Re: Onondaga Lake Capping, Dredging, Habitat and Profundal Zone (SMU 8) Final Design, Modified Protective Cap RA-D2 Design Revision, Dated May 2016

**ONONDAGA LAKE CAPPING, DREDGING,
HABITAT AND PROFUNDAL ZONE (SMU 8)
FINAL DESIGN**

**MODIFIED PROTECTIVE CAP RA-D-2
DESIGN REVISION**

SUMMARY OF DESIGN REVISION

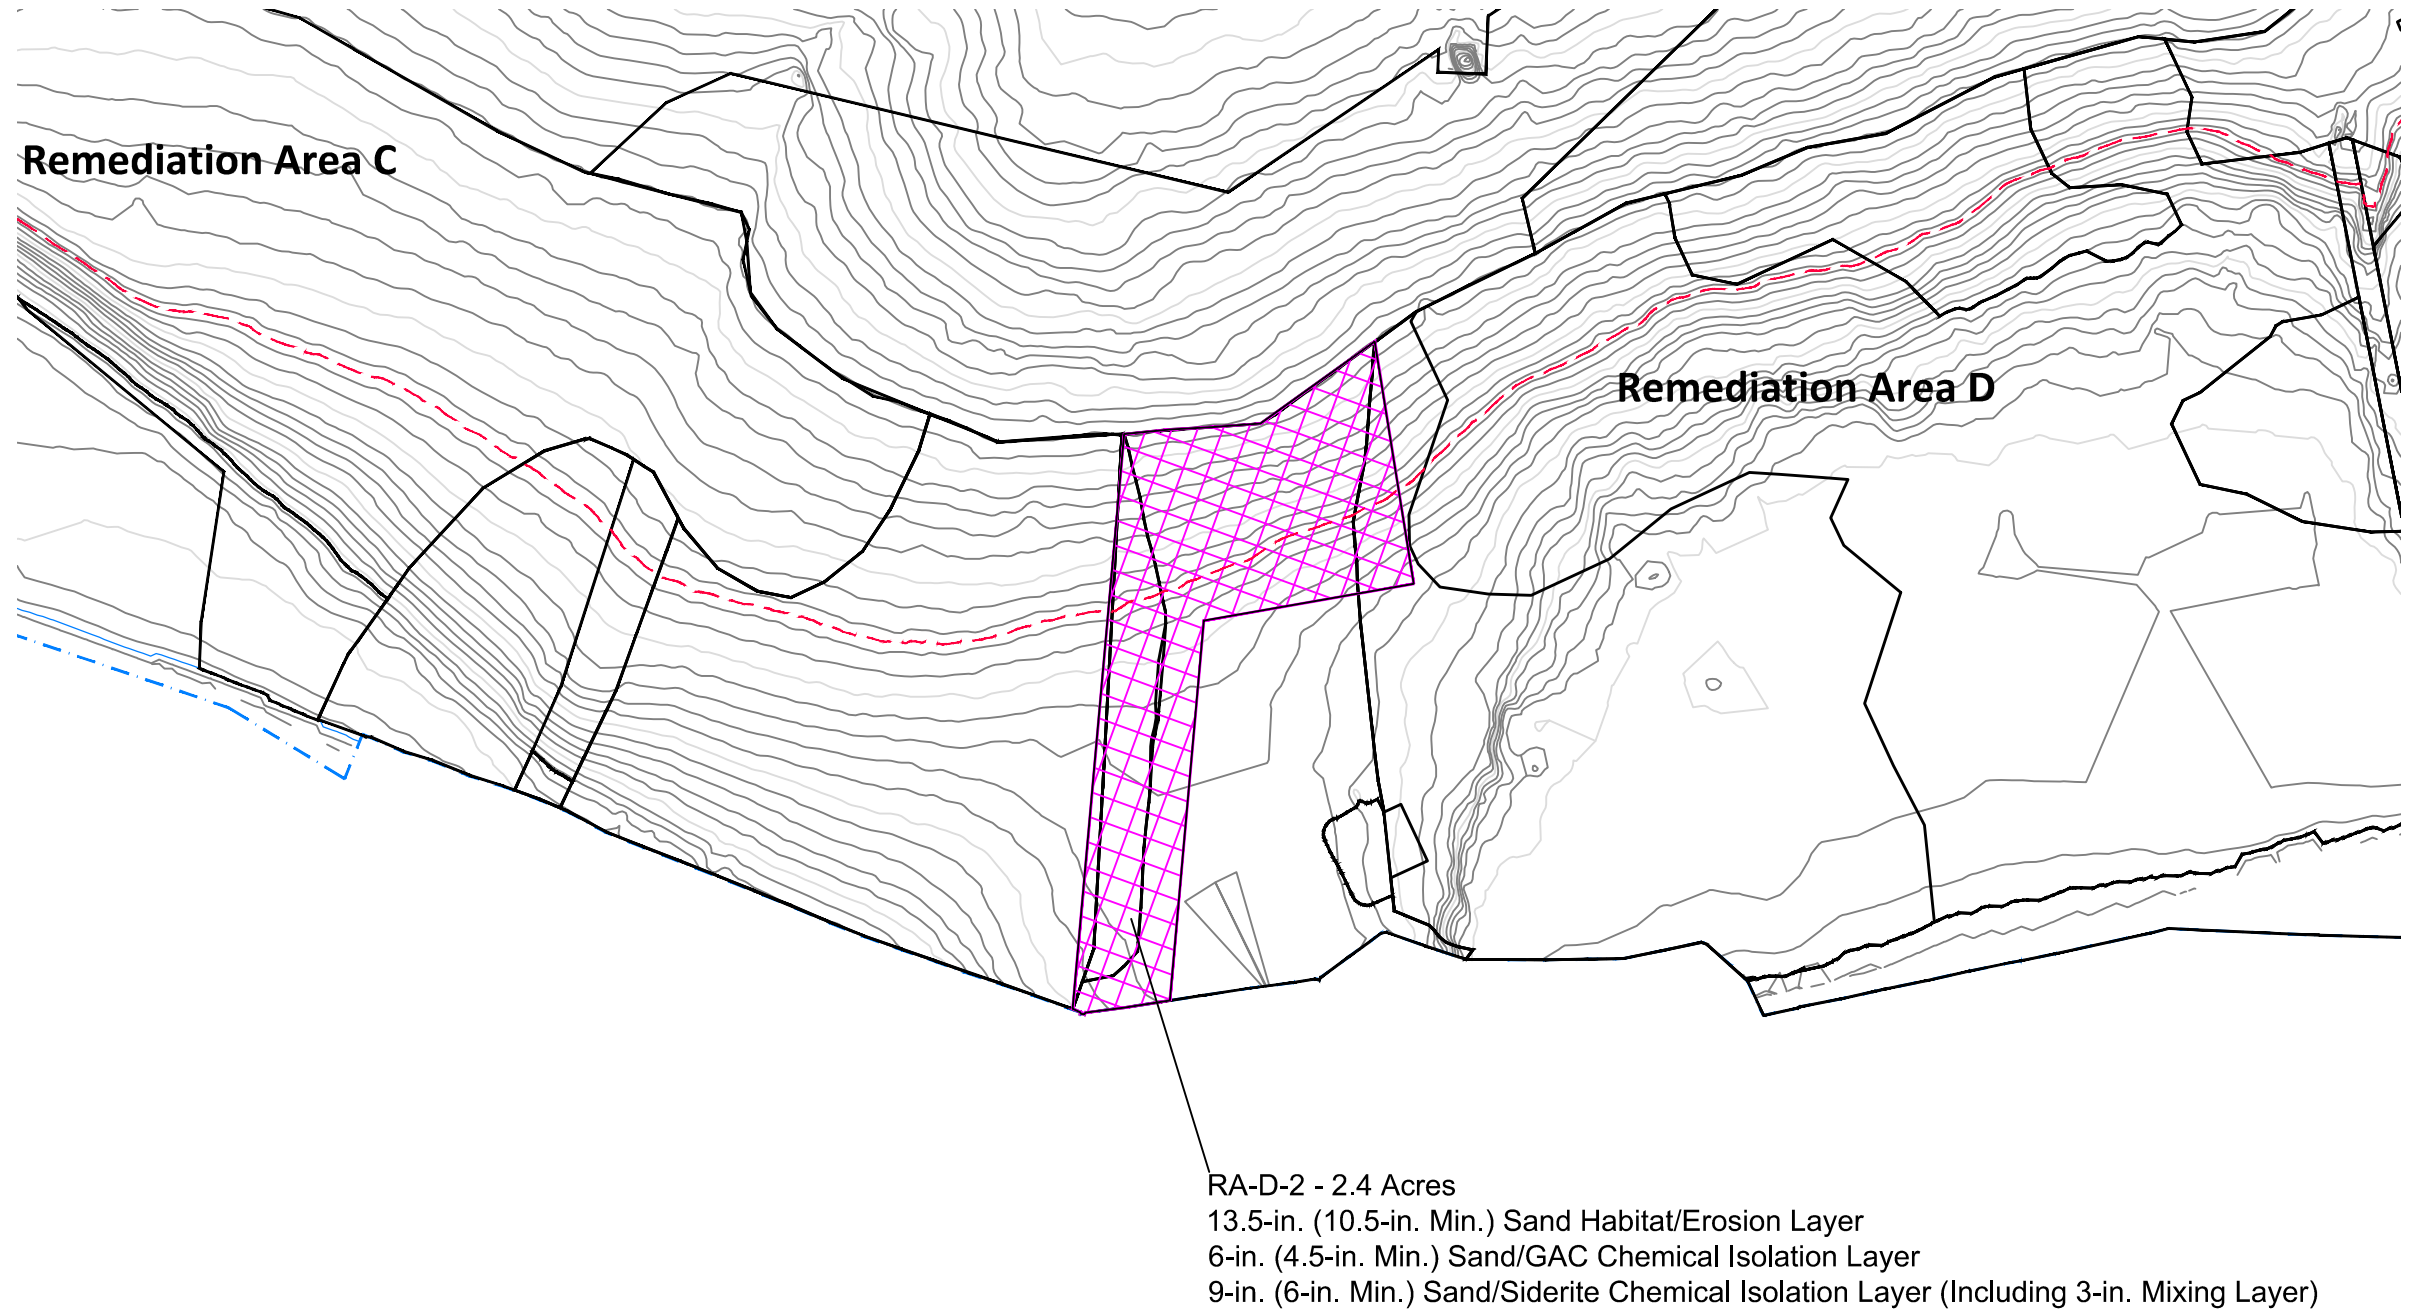
The Modified Protective Cap (MPC) design shown in Figure 1 was determined to be stable based on geotechnical data collected subsequent to the Final Design and detailed geotechnical analysis, as presented in Attachment 1. This analysis incorporates the results from field investigations performed with equipment that is both more accurate than that used during the 2005 to 2008 pre-design investigation (PDI) and capable of assessing conditions in the deeper water portions of the lake where softer sediments have been identified. This included cone penetrometer testing (CPT), full flow penetrometer (FFP), and additional vane shear testing (VST). In addition to the improved accuracy of these measurements, the use of these methods in areas of the site with previously placed cap materials has allowed an assessment of cap placement induced strength gain (from consolidation) in the sediment, which has been a key consideration in the slope stability assessments in some cap areas.

The MPC designs were optimized to maximize the total thickness of the cap while still meeting the required factor of safety based on geotechnical considerations. The thicknesses and composition of the various layers comprising the MPC are shown below as well as on Figure 1. Chemical isolation modeling was completed to determine the granular activated carbon (GAC) application rates that will be protective for more than 1,000 years, consistent with the evaluation timeframe used in the final design, as documented in Attachment 2. The thickness and composition of the various layers comprising the MPC, including the updated GAC application rate based on this modeling is also listed below.

RA-D-2 (Multi-layer Cap) - GAC application rate of 1.53 lbs/sf

- 10.5-inch minimum sand habitat/erosion protection layer
- 4.5-inch minimum sand/GAC chemical isolation layer
- 3-inch minimum sand/siderite chemical isolation layer
- 3-inch minimum sand/siderite mixing layer

Figure 6. Calculated factors of safety and critical slip surfaces for Cross Section 1.

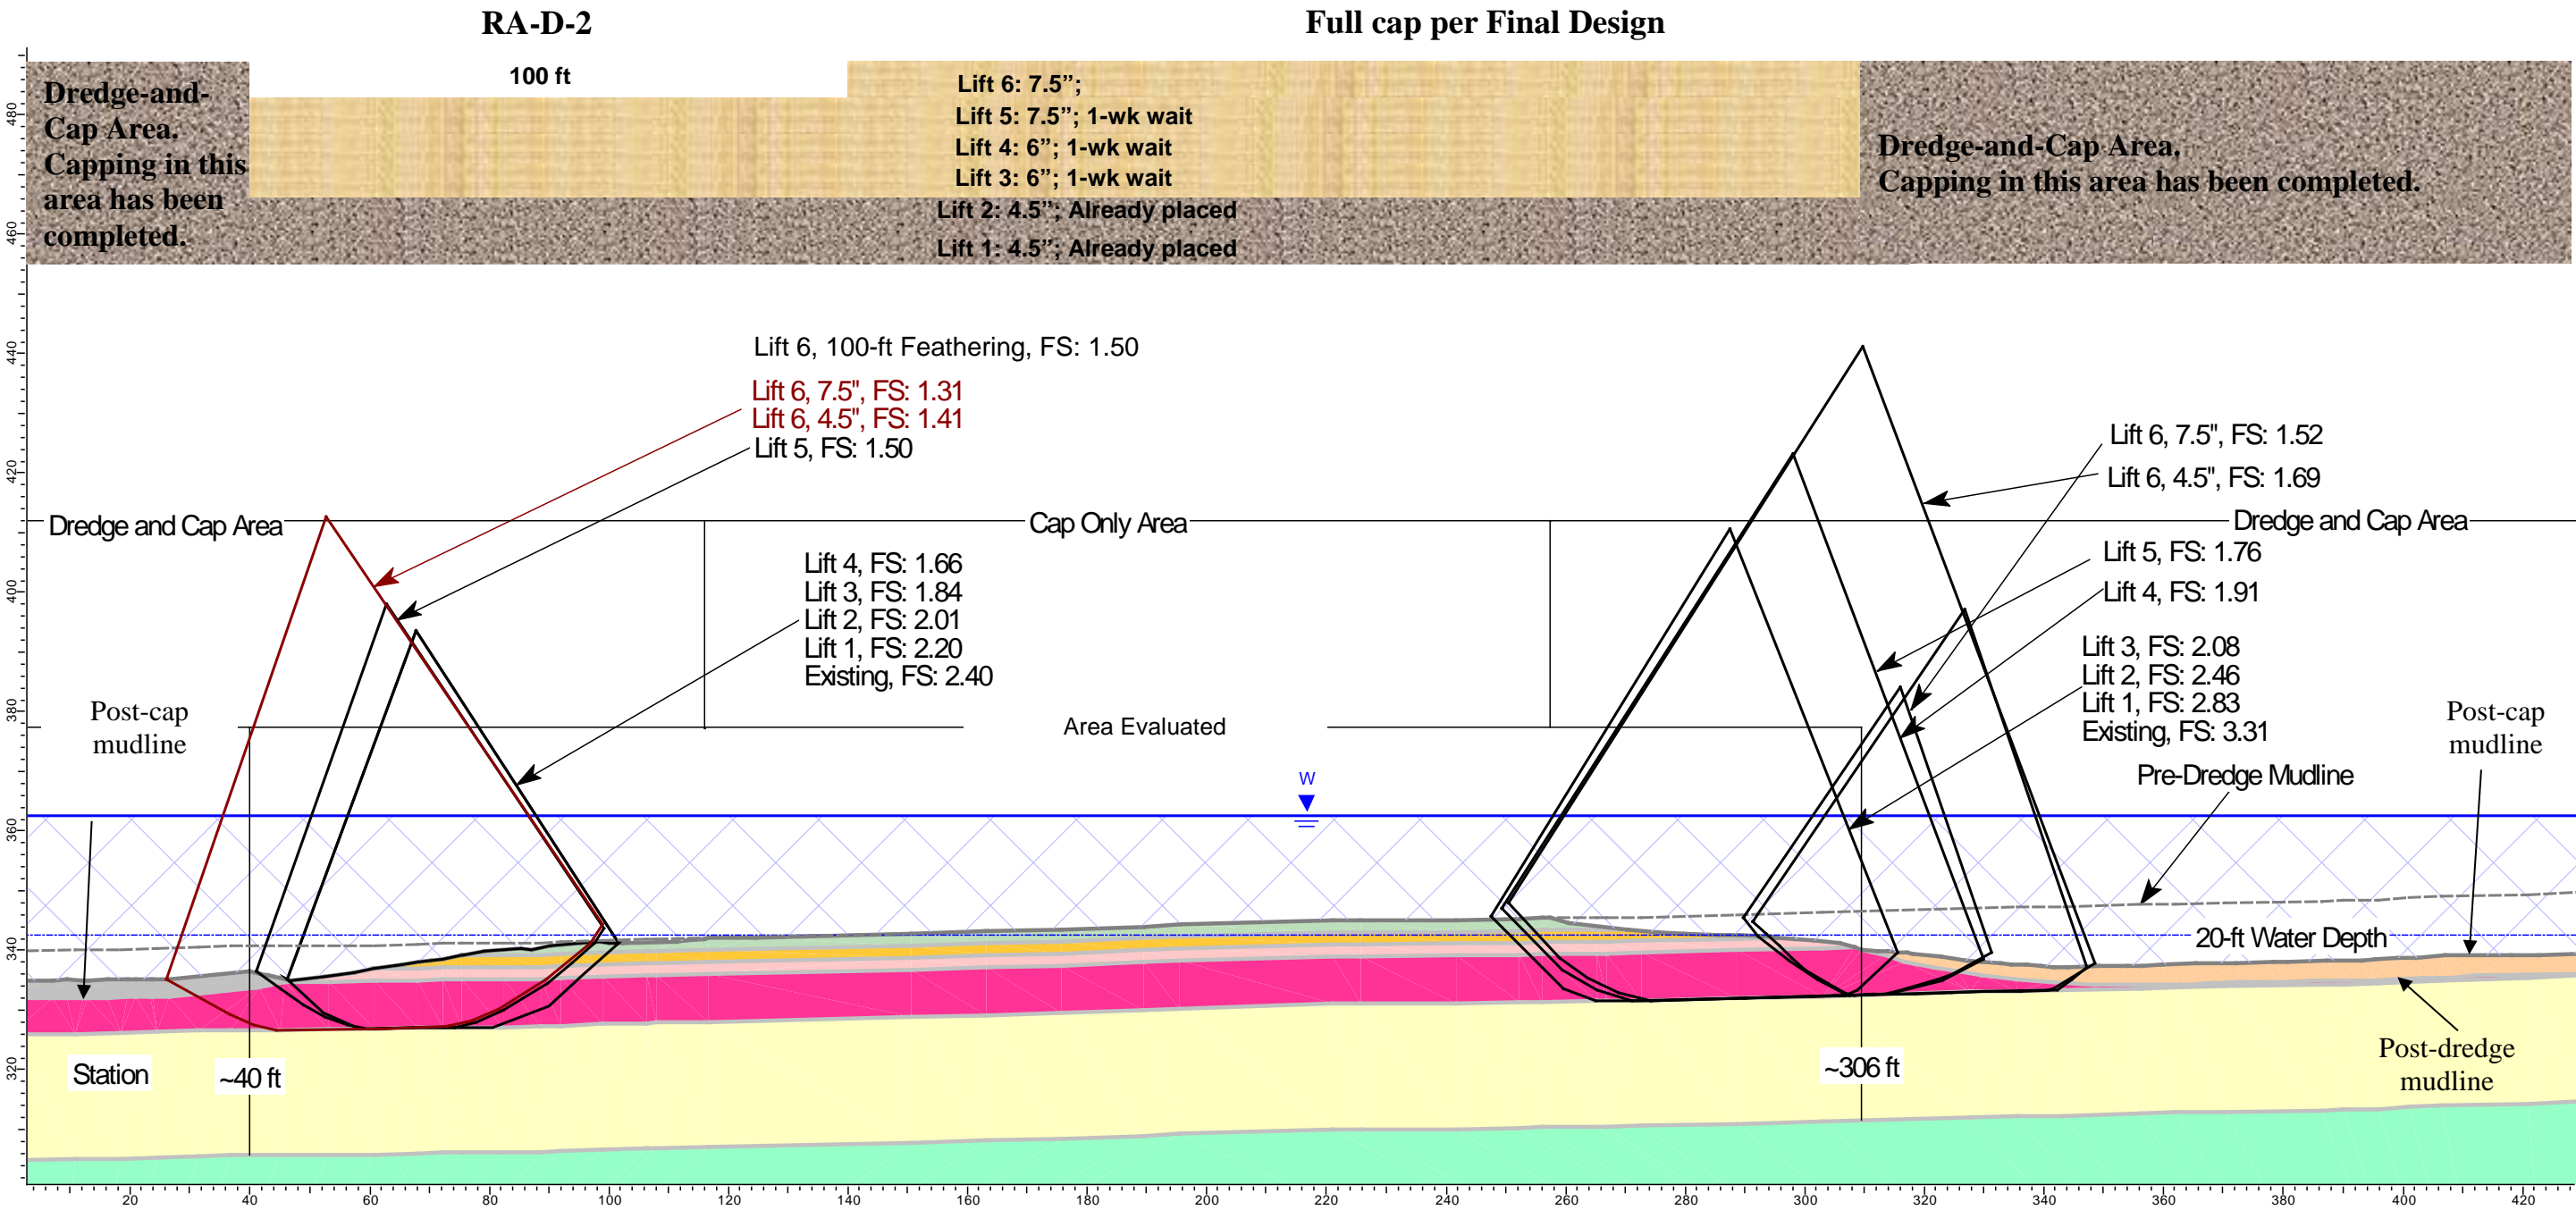
For Cross Section 1, the calculated slip surfaces on the western side of the cap-only area of RA-D-2 (i.e., left end of Cross Section 1) are shown in Figure 6 and the minimum calculated FS are listed in the table below.

The calculated slip surfaces on the eastern side of the cap-only area of RA-D-2 (i.e., right end of Cross Section 1) generally resulted in higher calculated FS compared to the western side of RA-D-2 as presented in Figure 6.

Based on the results shown above, a full cap thickness per Final Design with total of six lifts of cap (existing 2 lifts of 4.5 in. + additional 2 lifts of 6 in. + 2 lifts of 7.5 in.) with one-week wait time between lifts is recommended in a portion of the area where the cap is yet to be completed (see Figure 6), while a total of five lifts of cap (existing 2 lifts of 4.5 in. + additional 2 lifts of 6 in. + 1 lift of 7.5 in.) with one-week wait time between lifts is recommended in RA-D-2. The calculated slip surfaces for the last four lifts of cap (i.e., Lifts 3 to 6) during cap placement are deep, through the weak layer with an undrained shear strength value of 45 psf at depths of approximately 6 to 14 ft below the lake bottom (see Figures 3 through 5); therefore, practical additional wait time between lifts (a few weeks to a month) would not affect the strength gain of sediments and the cap stability due to a long drainage path for the deep weak sediment and negligible degree of consolidation. The calculated FS after placement of Lift 6 in RA-D-2 with 7.5-in. thickness is 1.31 and with 4.5-in. thickness is 1.41, which is below the target FS of 1.5.

Figure 7. Calculated factors of safety and critical slip surfaces for Cross Section 2.

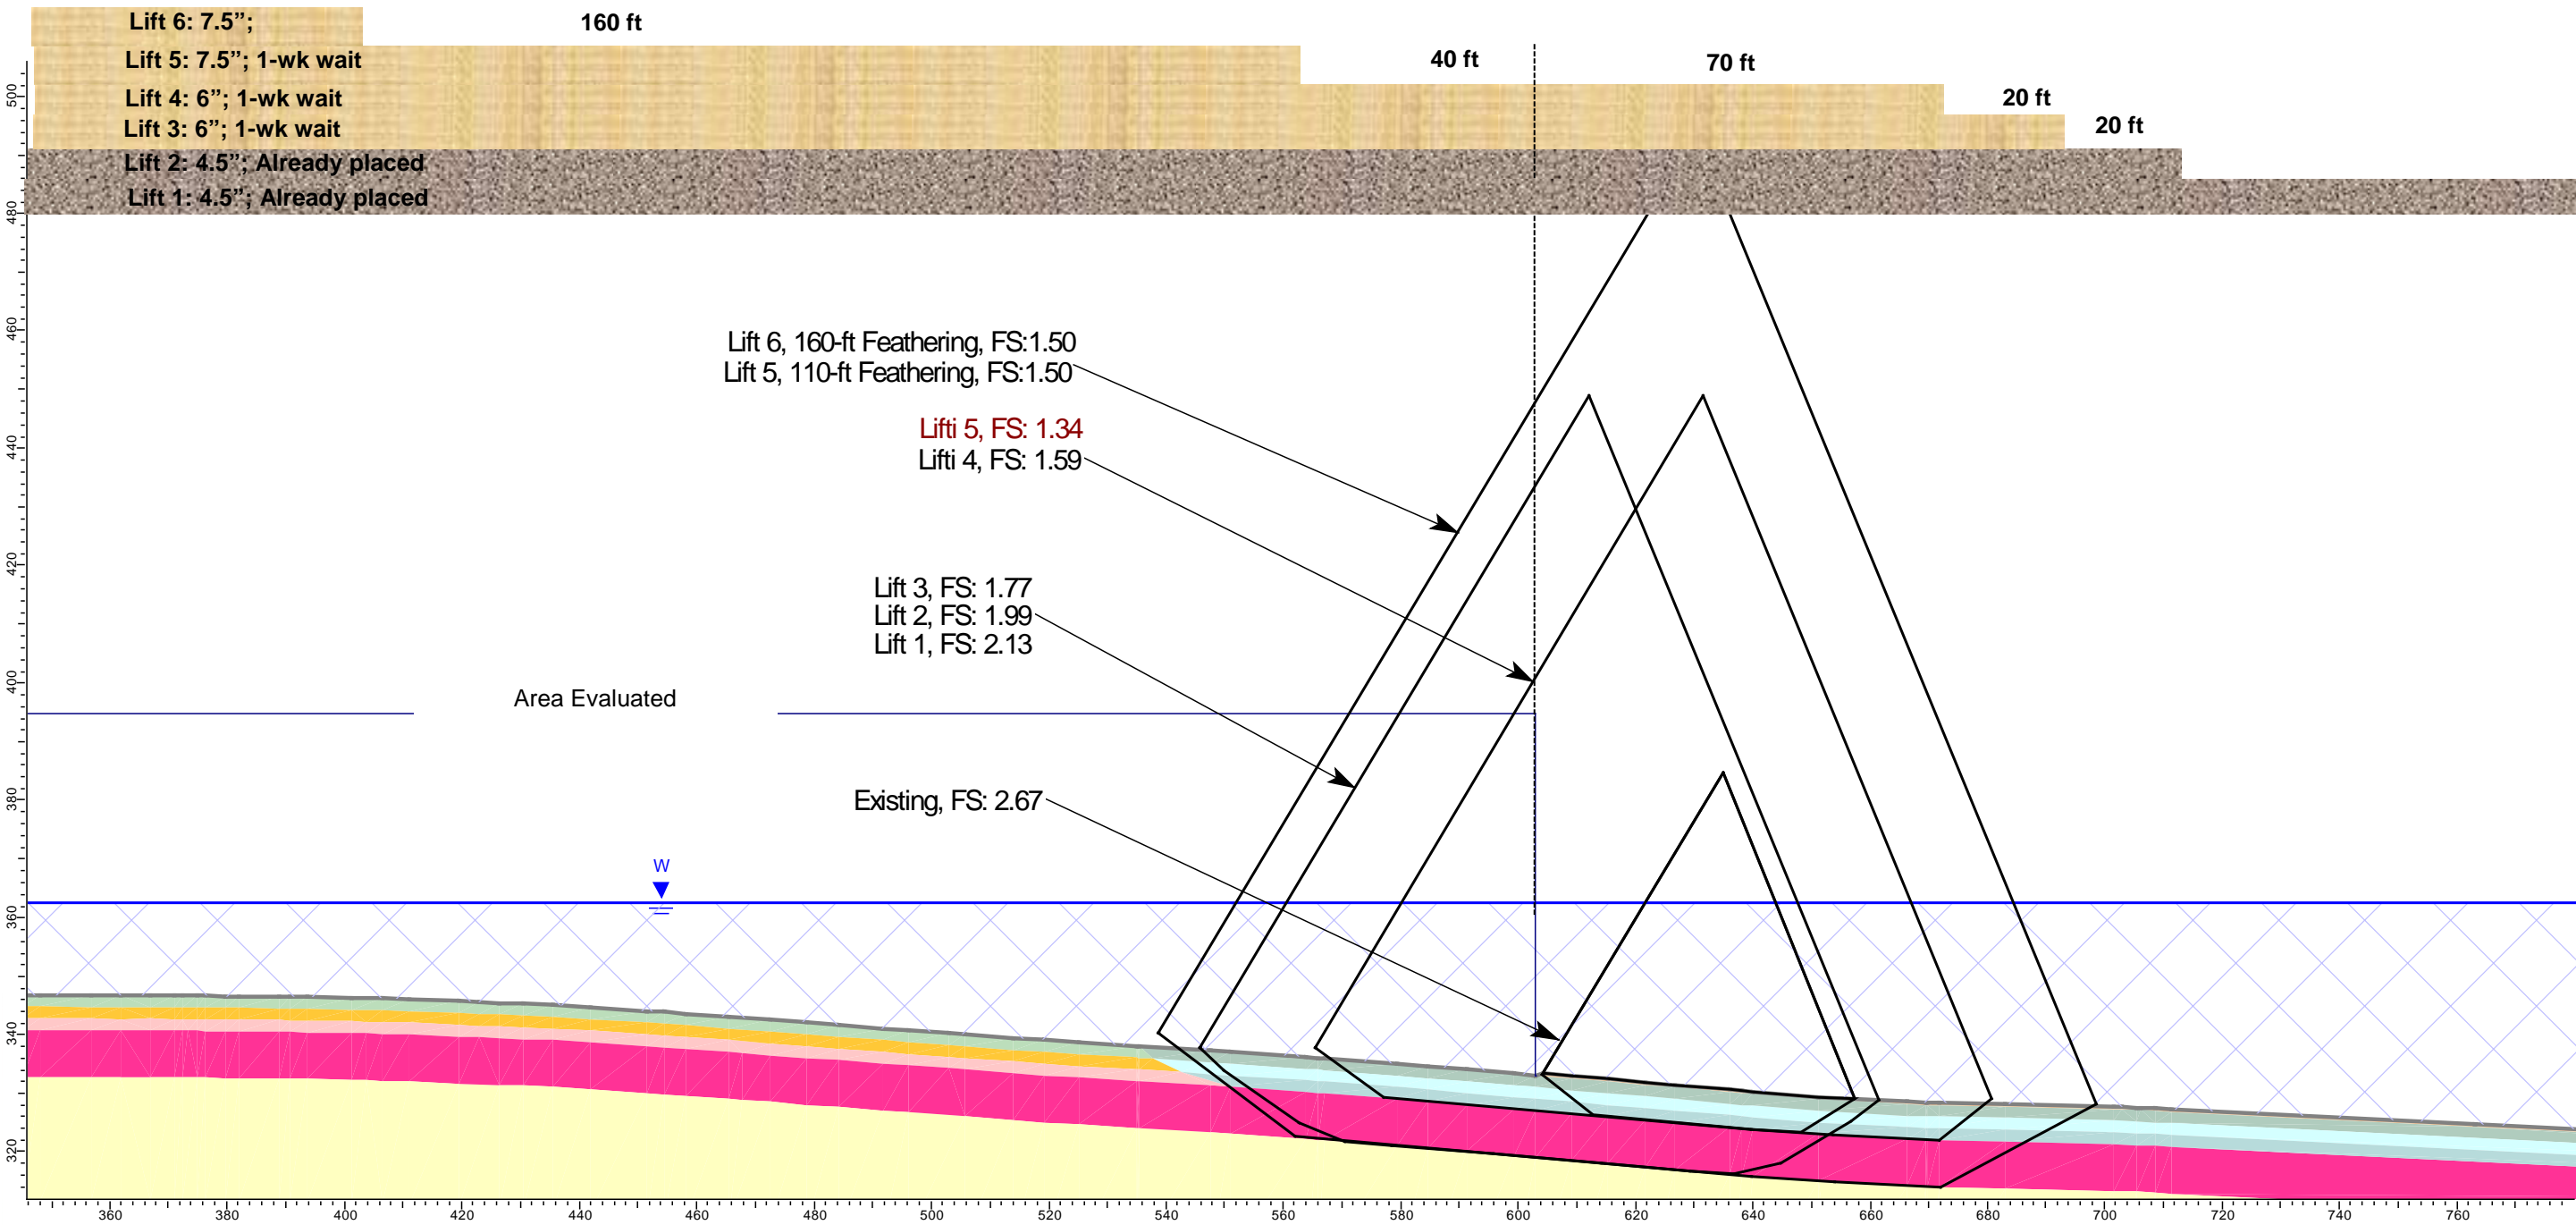
Cross Section 2 was analyzed to estimate the required feathering and extension into SMU-8 at the northern edge of RA-D-2. For Cross Section 2, the calculated slip surfaces are shown in Figure 7 and the minimum calculated FS are listed in the table below.

**** The cap is required to be set back about 160 ft in order to place Lift 6, as shown in Figure 7. Five lifts will be placed within this setback area (see Figure 7)

The calculated FS after placement of Lift 6 with smaller feathering (i.e., 20 ft) and with 7.5-in. thickness is 1.37 and with 4.5-in. thickness is 1.42, which are below the target FS of 1.5. Therefore, a 160-ft setback is required to place the full cap thickness per Final Design, as shown in Figure 7. The calculated 160 ft of feathering is due to the geometry of the slope and is required in order to improve the stability of the full cap within the flatter portion of slope in the area before Station 400 ft shown in Figure 7.

Based on the results shown above, a total of five lifts of cap (existing 2 lifts of 4.5 in. + additional 2 lifts of 6 in. + 1 lift of 7.5 in.) with one-week wait time between lifts, and the extensions into SMU-8 presented in the table above and Figure 7 are recommended in RA-D-2. The staggered downslope edge shown in Figure 7 is required due to the presence of a deep weak layer of soft sediments and relatively steeper slopes, as shown in Figure 4. This weak layer has an undrained shear strength value of 45 psf at depths of approximately 6 to 14 ft below the lake bottom. It should be noted that FFP-15-D1 and FFP15-D1A are located below the footprint of
